BN/29/15/PL

PLAN-010806

Proposal: Solar park including the erection of solar arrays, inverters, transformers, equipment housing, security fencing, internal tracks, ancillary equipment & ecological mitigation. This is a Departure from the Development Plan.

Site: Land at Barnham Court, Barnham, PO220BU.
BN/29/15/PL

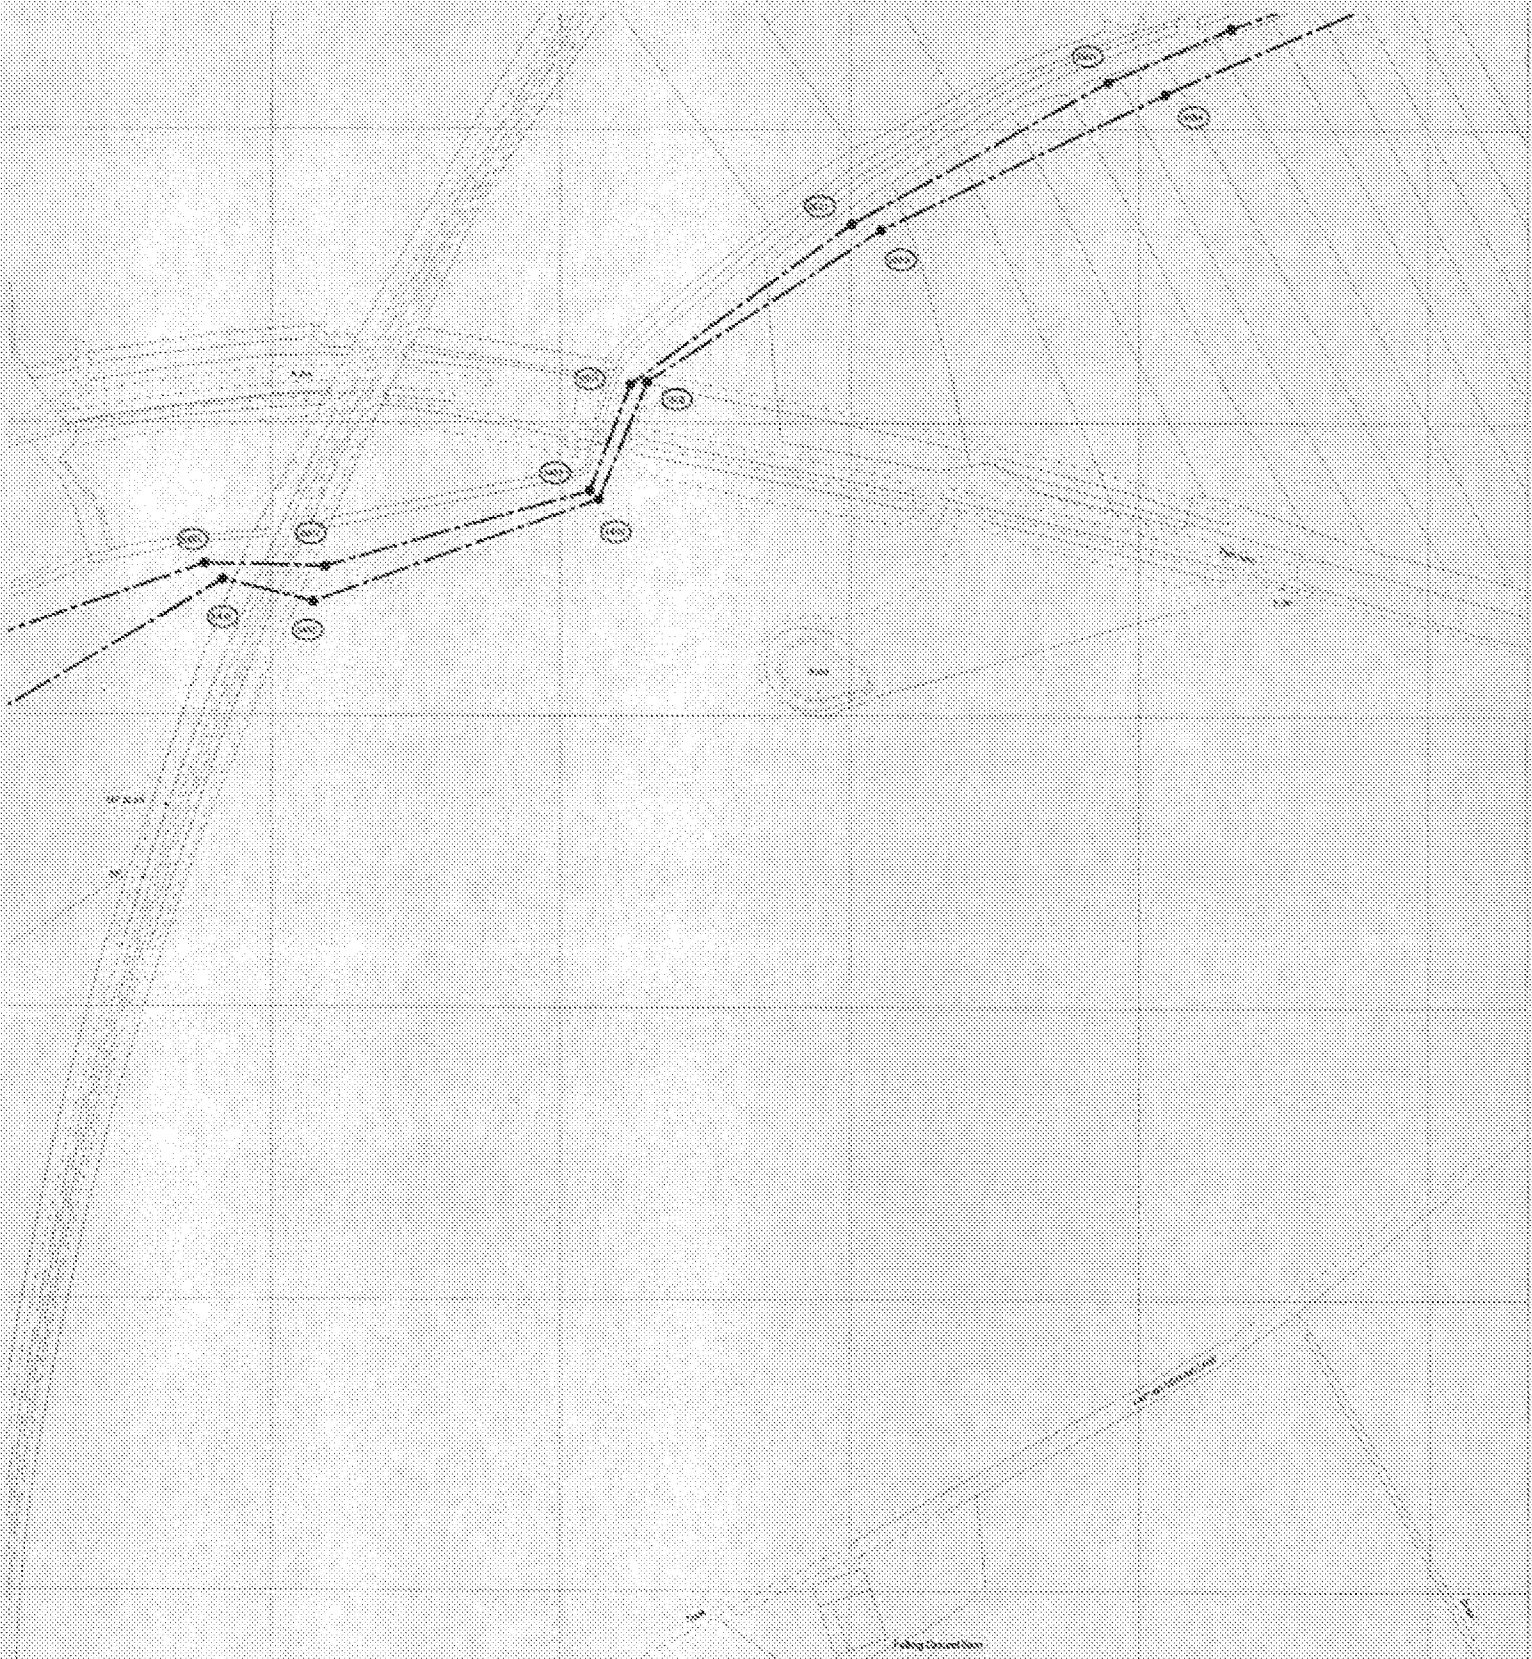
Please find attached a plan of the sewer records showing the approximate position of foul sewer within the site. The exact position of the foul sewers must be determined on site by the applicant before the layout of the proposed development is finalised.

- No development/structures or excavation or new tree planting should be located within 3 metres either side of the centreline of the public sewer.
- No new soakaways should be located within 5 metres of a public sewer.
- All existing infrastructure should be protected during the course of construction works.
